Product Discontinuation Notice WW2200, January 2022

Cross-Connection Discontinuation – ZQV...N (W-series)

-Revised-

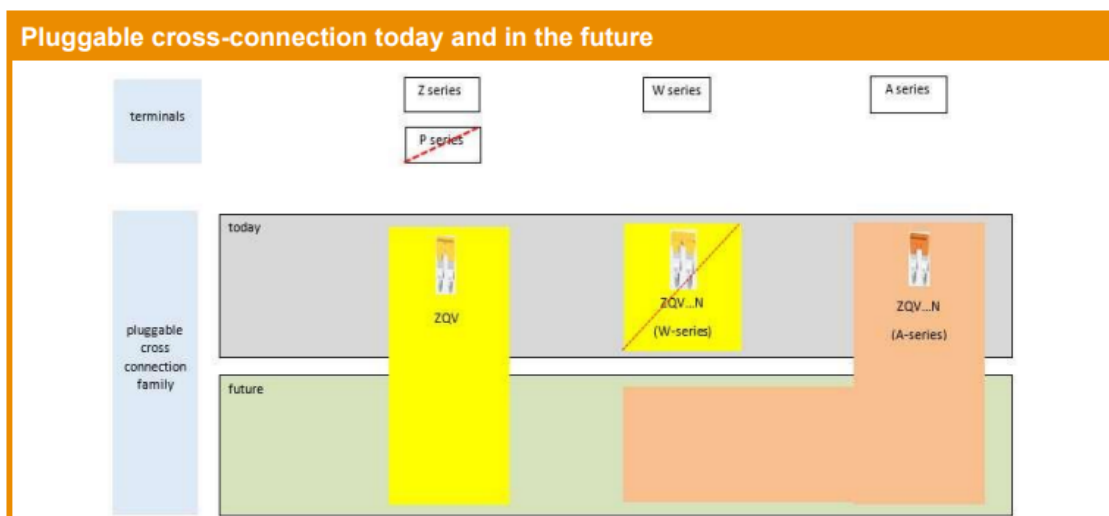
Weidmuller would like to inform you about a recent product discontinuation. The ZQV cross-connectors of our W-series will be replaced with the ZQV cross-connectors from our A-series. This decision was made to avoid handling mix-ups with the same-colored (Yellow) cross-connectors from our Z-series and to simplify product variety.

Exception: ZQV...N 1.5 cross-connectors for the W-series terminals WDU1.5 & WDK1.5 will not be replaced at this point and remain unchanged.

Restrictions when cross-connectors are used with the following terminal blocks:

- ZDL 2.5 → cross-connector cannot be used in combination with SIHA3 fuse holder plug
- ZDUA / ZDUB → cross-connector cannot be used in combination with central marker
- ZT 2.5.../ ZDT 2.5.../ ZTTR 2.5 (WEICOS) → cross-connector cannot be used in combination with cross-connector "...2AN/QV..."
- WDU 4 & WMA 4 → cross-connector cannot be used in combination with WAD 5 marker
- WDU 4N → cross-connector cannot be used in combination with WAD 4

- markers or WTA 1 test adapters
- WDK 4N → terminal connecting point above the cross-connection: ferrules collide with the cross-connection
- P-Series → ZQV...N of the A-series is 5.08 mm higher → not finger-safe
